Subject: UMTRA PROJECT: Review Comments on Documents for Working  
Group 2 - Geotechnical Stability

COMMENTS: DRAFT STANDARD REVIEW PLAN FOR GEOLOGIC-SEISMOLOGIC  
REVIEWS OF UMTRAP DOCUMENTS

DRAFT STANDARD REVIEW PLAN  
FOR GEOLOGIC AND SEISMOLOGIC REVIEWS  
OF UMTRAP DOCUMENTS

FIG. 1

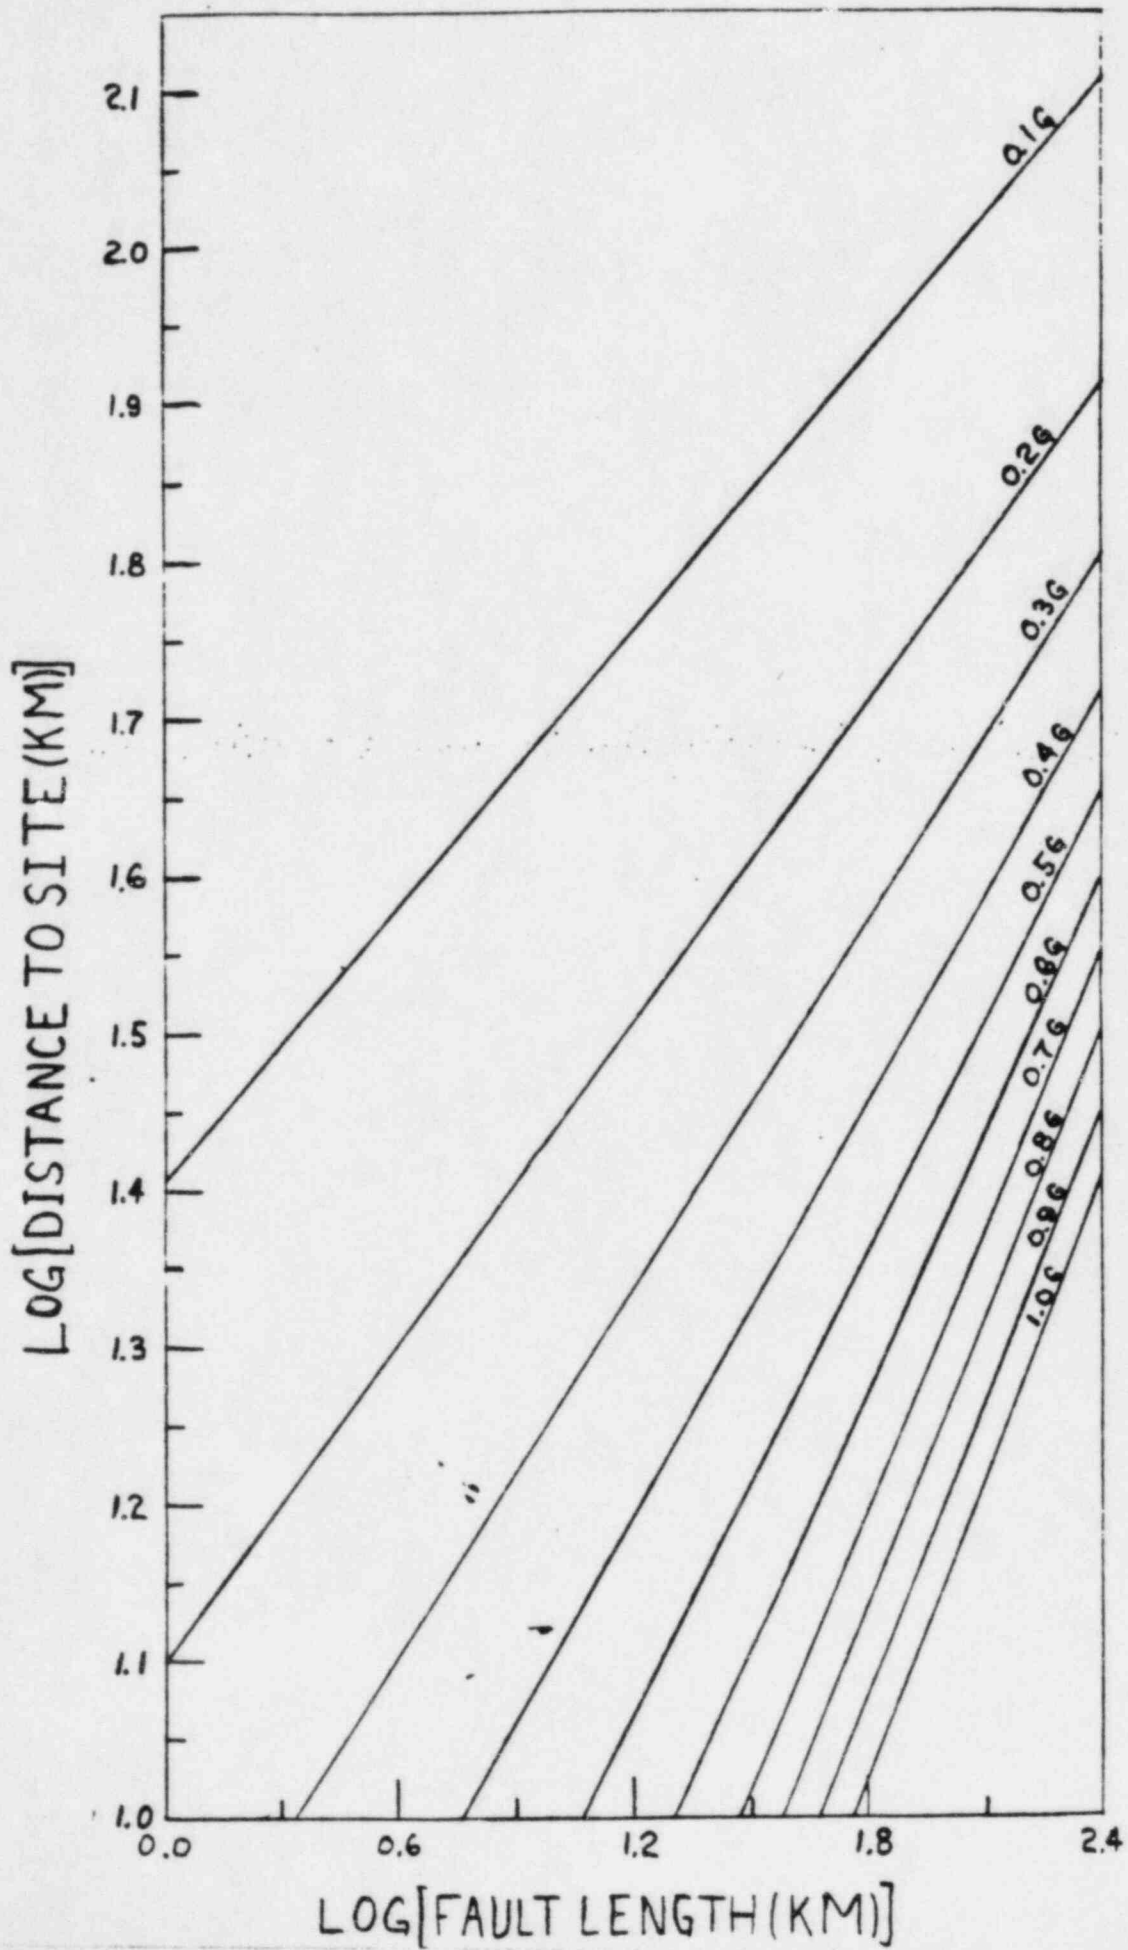
Step (2), Determination of Area for Fault Investigation and Identification of Faults to be Investigated. By reference to Figure 1 (derived from relationships of Joyner and Boore, 1981, and Bonilla et al., 1984.), which presents a family of curves relating fault lengths to closest fault-to-site distances for different accelerations, a determination should be made of where the curve for the maximum peak horizontal acceleration value obtained in Step 1 intersects the log fault length value of 2.4. For all faults within this area, the fault length and distance to the site should be noted. With this information, it should be determined whether a point for a fault, plotted on Figure 1, lies above or below the acceleration curve corresponding to the maximum peak horizontal bedrock acceleration value obtained in Step 1. For points that fall above the curve, no further investigation is necessary. For points that lie below the curve, the maximum earthquake magnitude that can be associated with a particular fault should be determined using a relationship between the length of the fault and the size of the earthquake it could generate (assuming that the fault is seismogenic). Acceptable state-of-the-art relationships, such as those of Bonilla et al., 1984, or Slemmons et al., 1982 should be used. Ground motion should be attenuated to the site using the attenuation relationships described in Step (1).
